United Nations ECE/TRANS/WP.29/2018/64

Proposal for Corrigendum 1 to Supplement 9 to the 06 series of amendments to UN Regulation No. 16 (Safety-belts)

Corrigendum 1 to Supplement 9 to the 06 series of amendments to UN Regulation No. 16 (Safety-belts)

"Figure 2

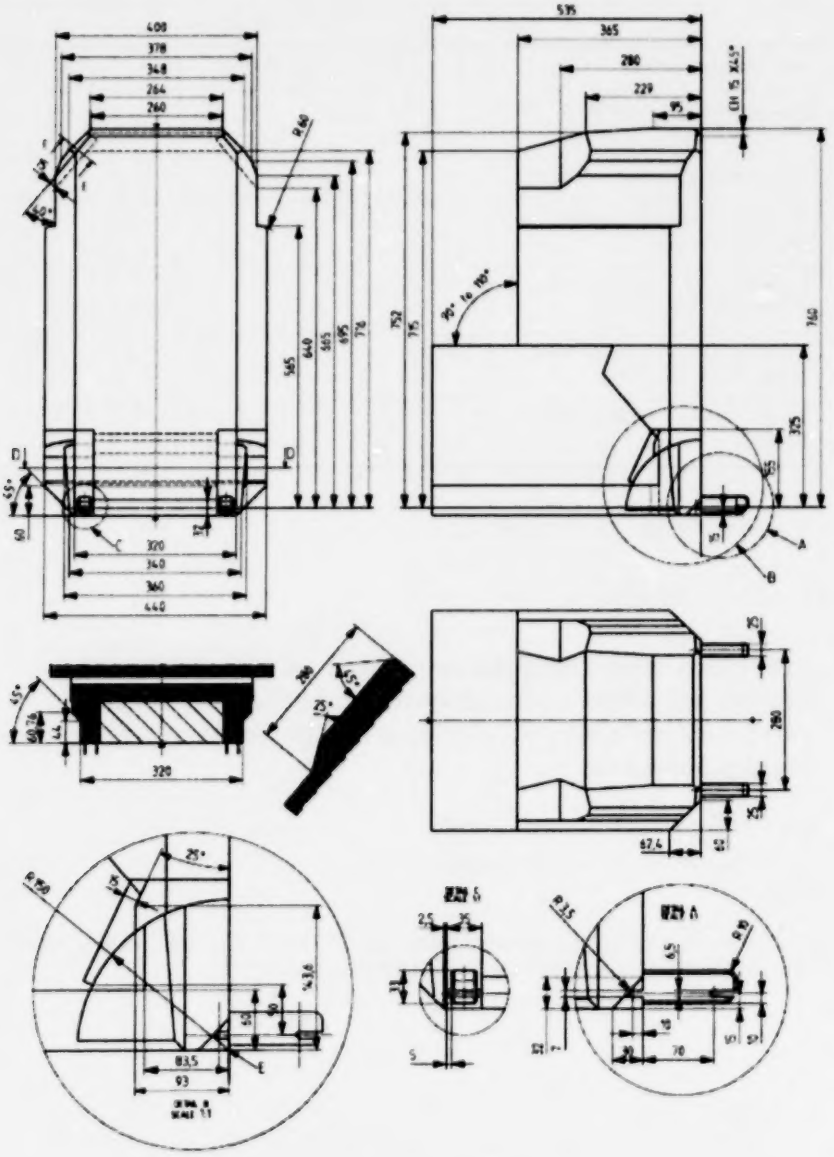
Appendix 5, figure 2 ISO B2, to be replaced as follows:

"Figure 3

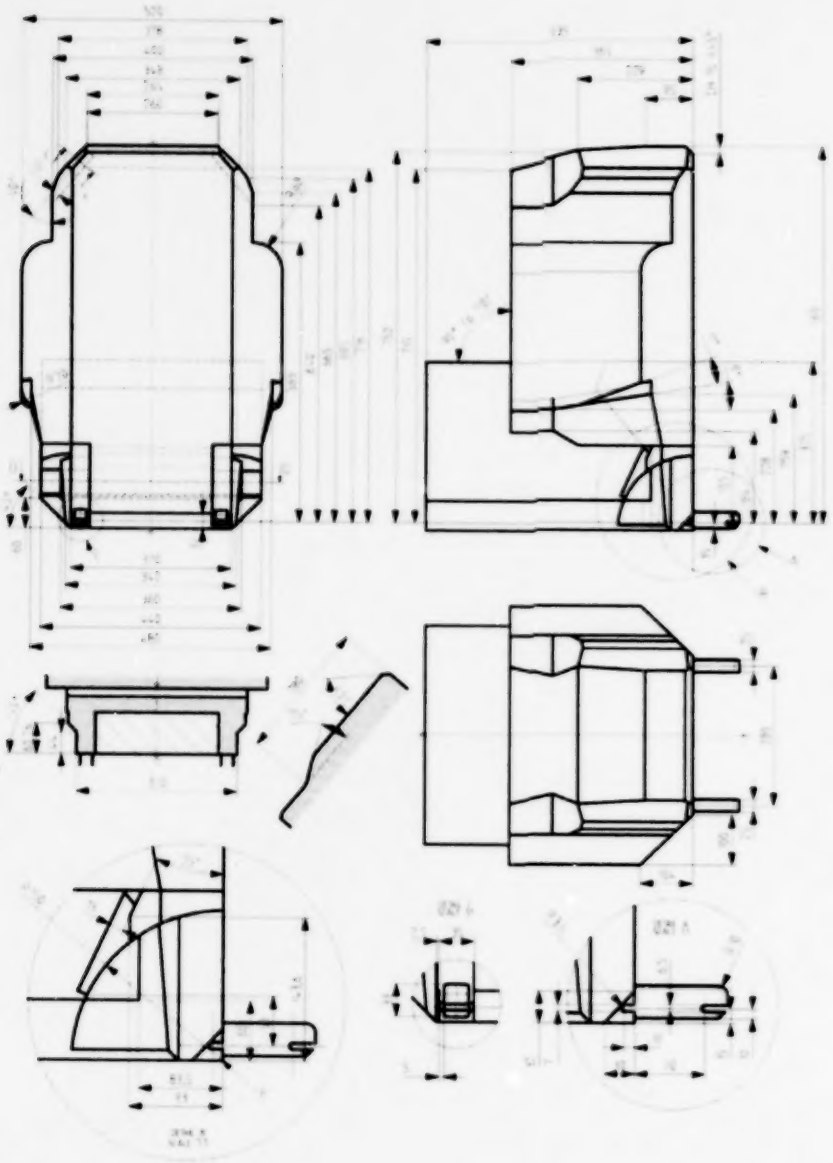
Appendix 5, Figure 3 ISO/B3, to be replaced as follows:
